PLANS AND DOCUMENTS referred to in the PDA DEVELOPMENT APPROVAL

Approval no: DEV2025/FLA/4175
Date: 06 February 2026

PROJECT
HERCULES STREET

SITE ADDRESS
19 HERCULES ST HAMILTON, BRISBANE QLD 4000

DRAWING TITLE
LEVEL 12

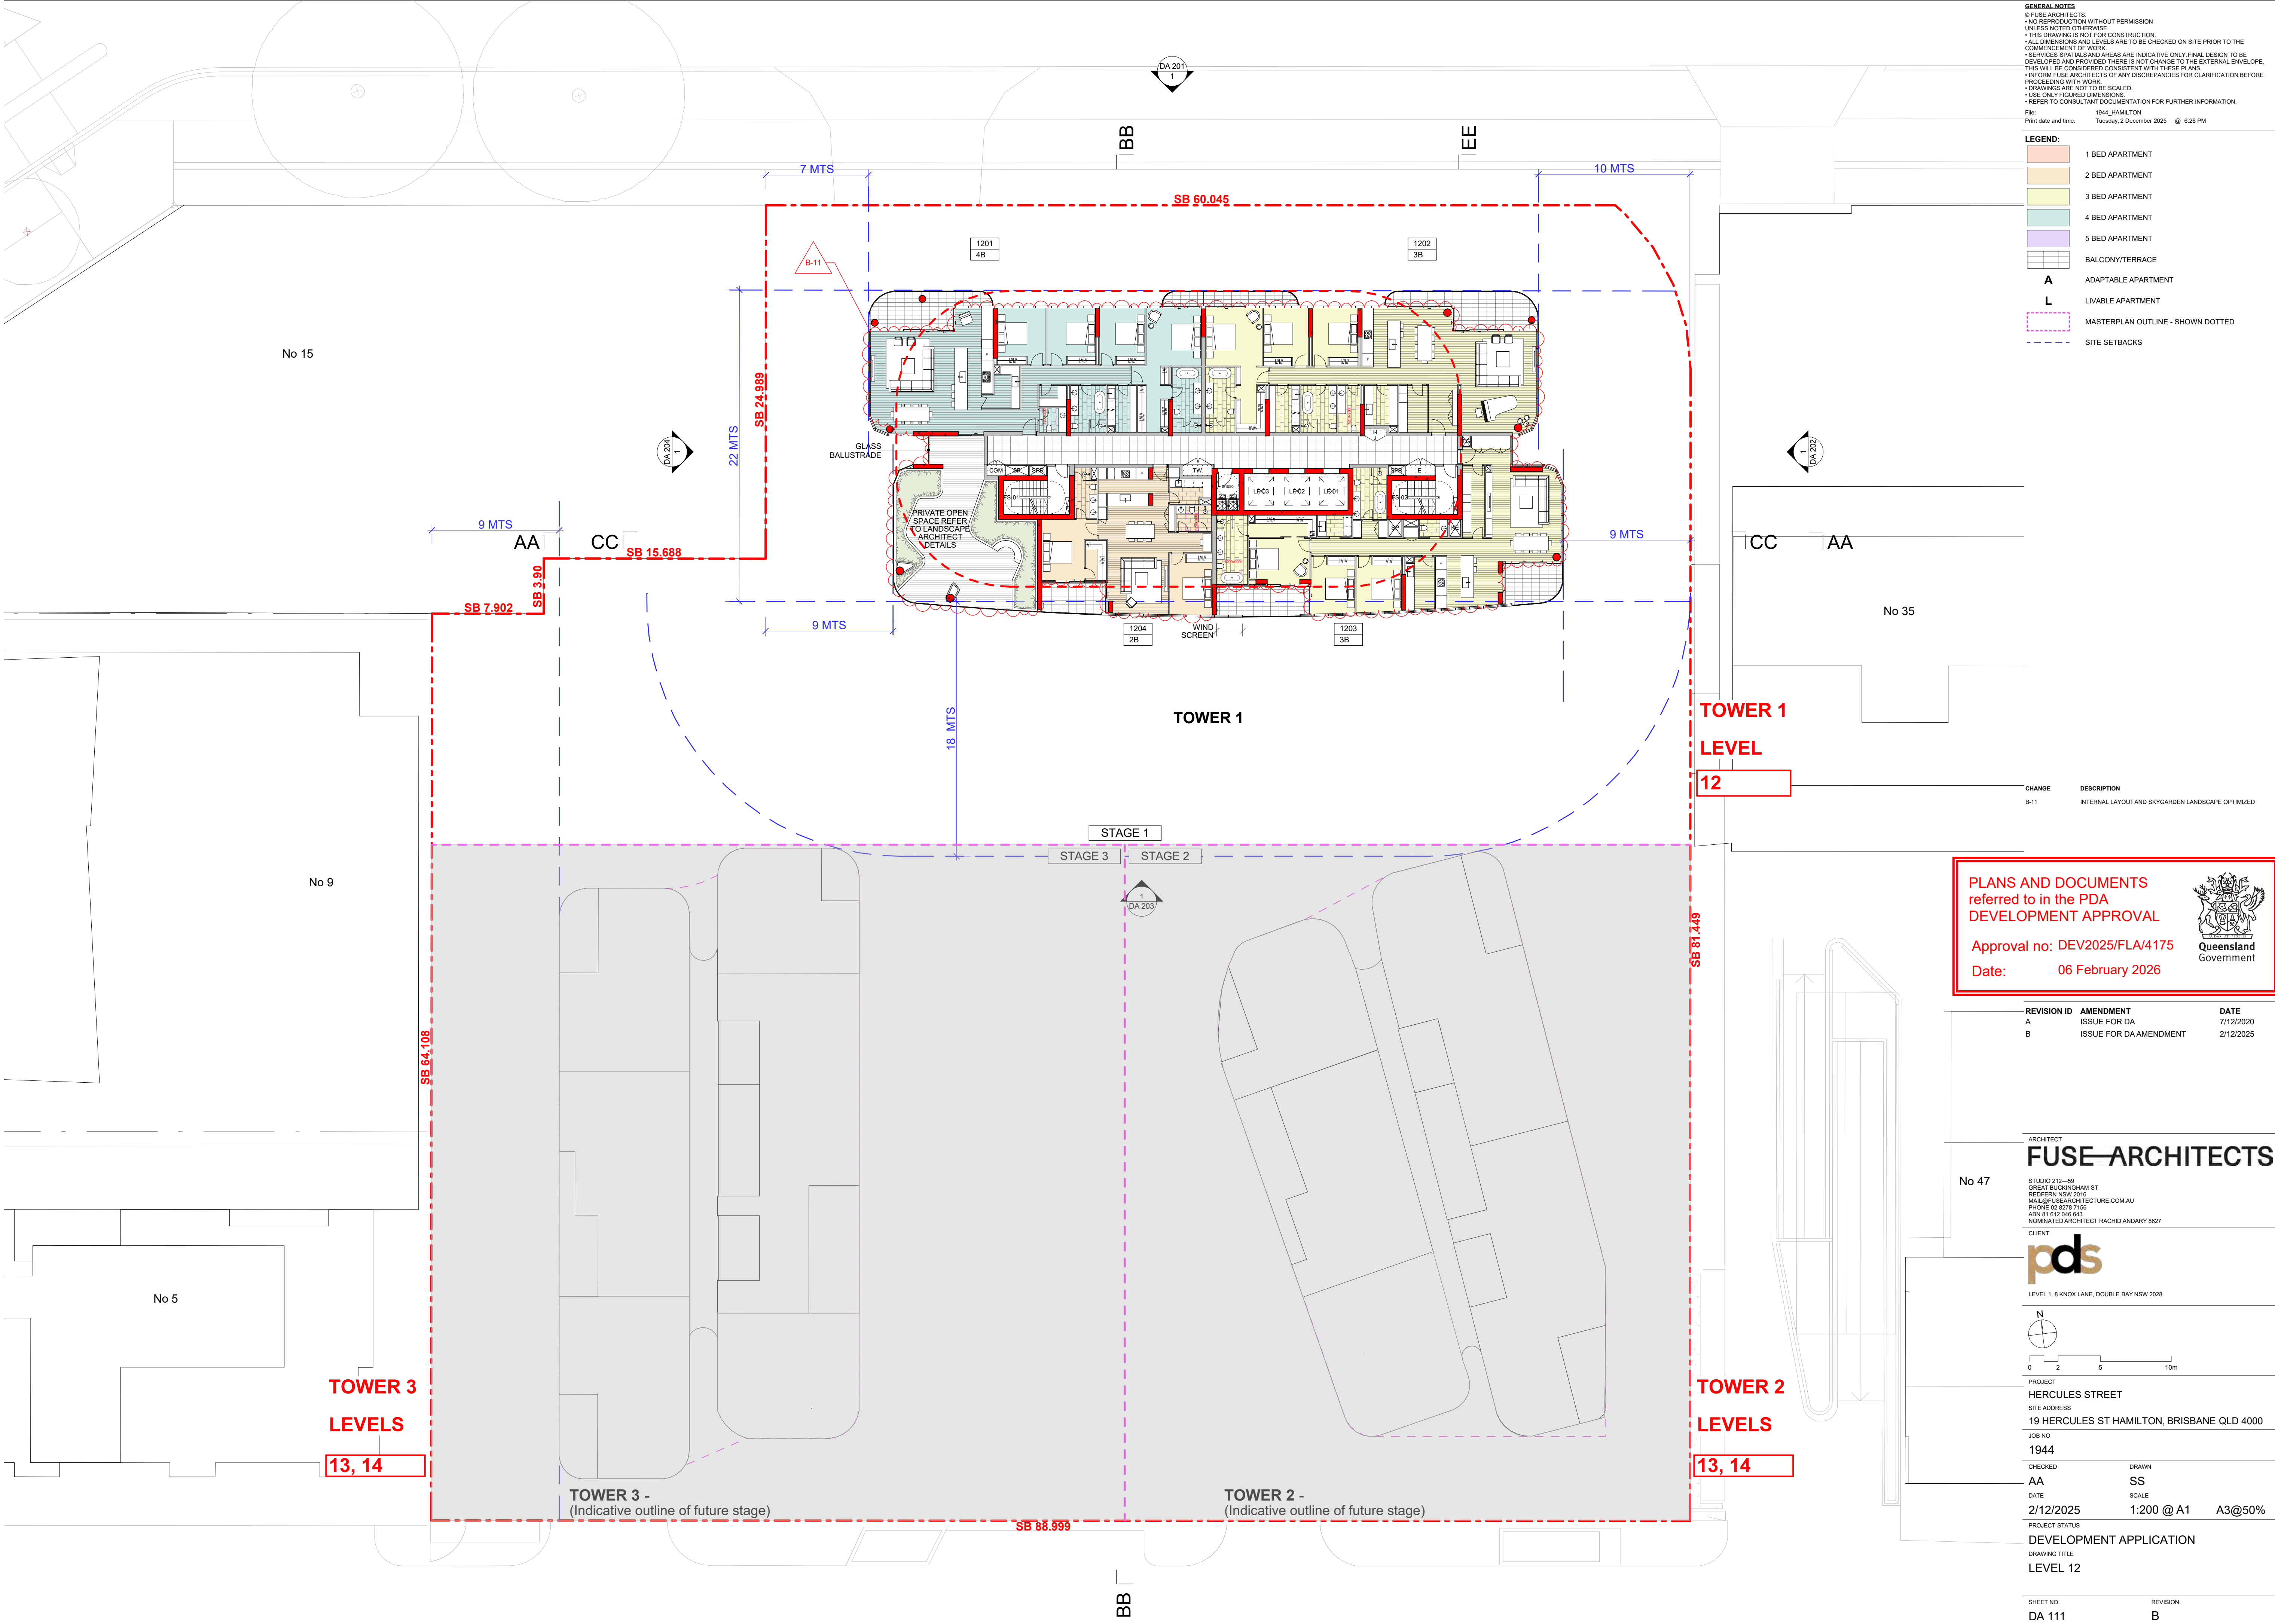
CHANGE	DESCRIPTION
B-11	INTERNAL LAYOUT AND SKYGARDEN LANDSCAPE OPTIMIZED

PROJECT
HERCULES STREET
SITE ADDRESS
19 HERCULES ST HAMILTON, BRISBANE QLD 4000
JOB NO
1944
CHECKED
AA
DATE
2/12/2025
PROJECT STATUS
DEVELOPMENT APPLICATION
DRAWING TITLE
LEVEL 16

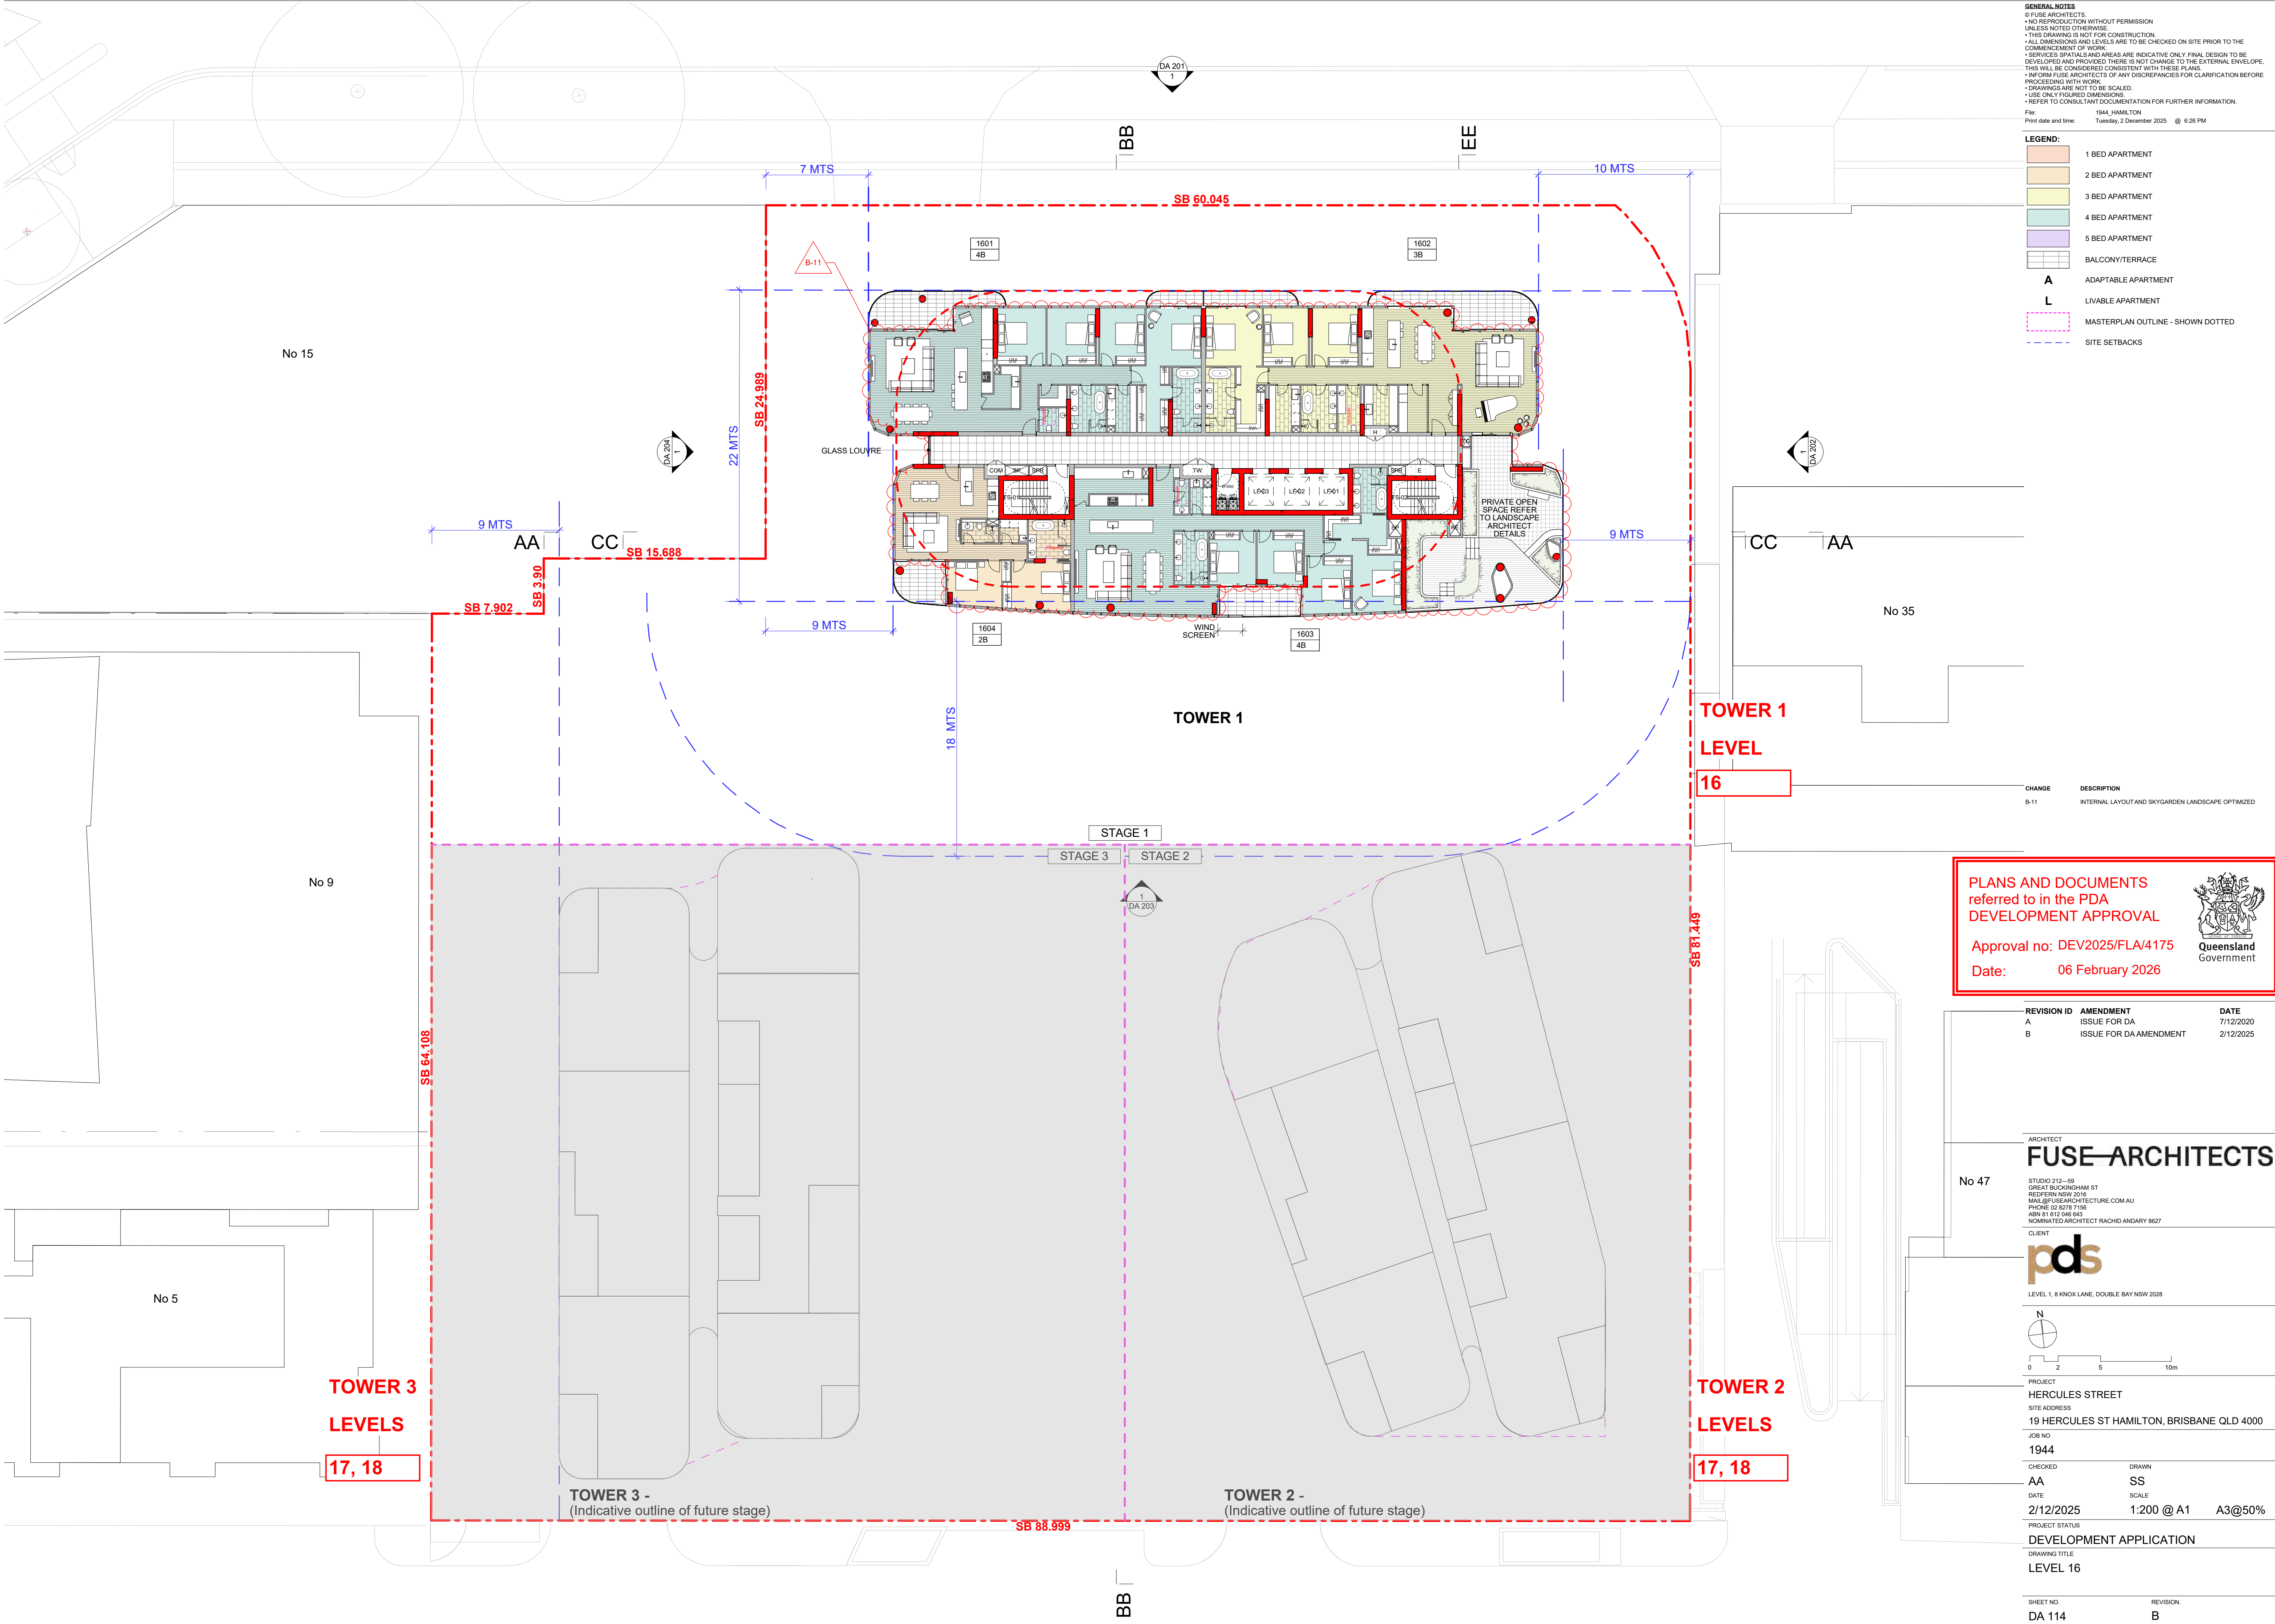
CHANGE	DESCRIPTION
B-11	INTERNAL LAYOUT AND SKYGARDEN LANDSCAPE OPTIMIZED

DRAWING TITLE
LEVELS 18 + 19 PLANS (TYP UPPER)

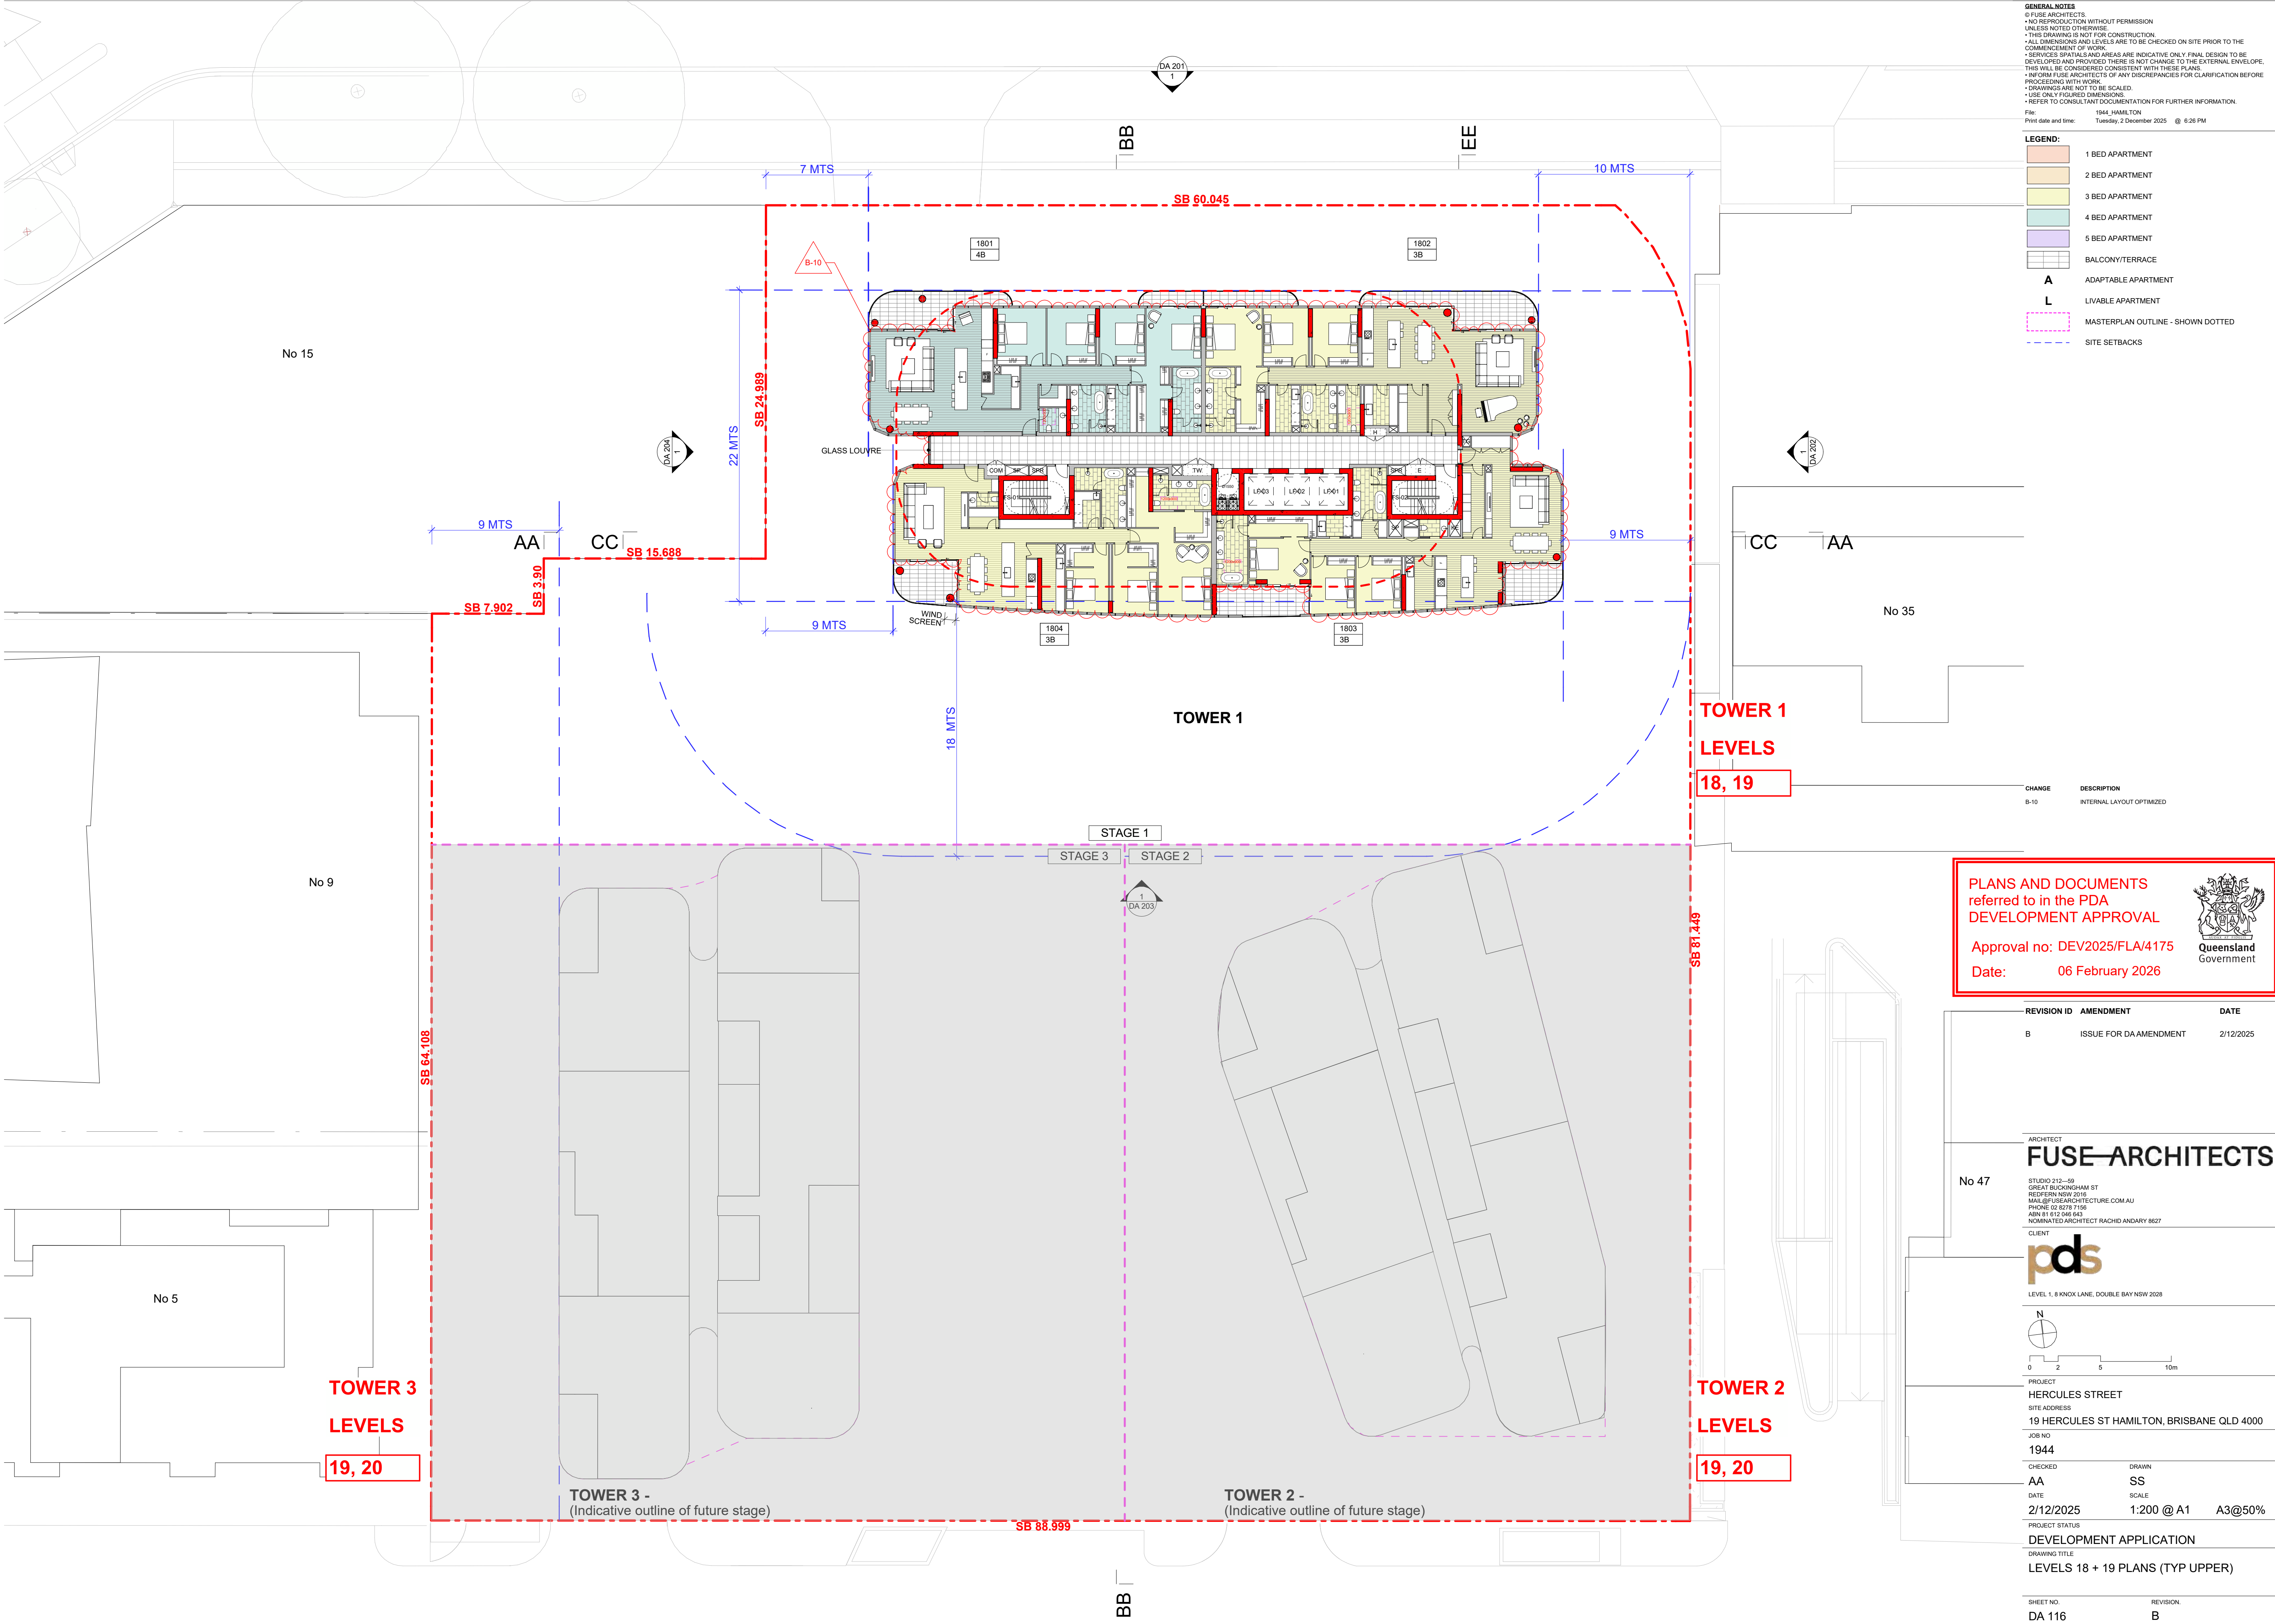
CHANGE	DESCRIPTION
B-10	INTERNAL LAYOUT OPTIMIZED
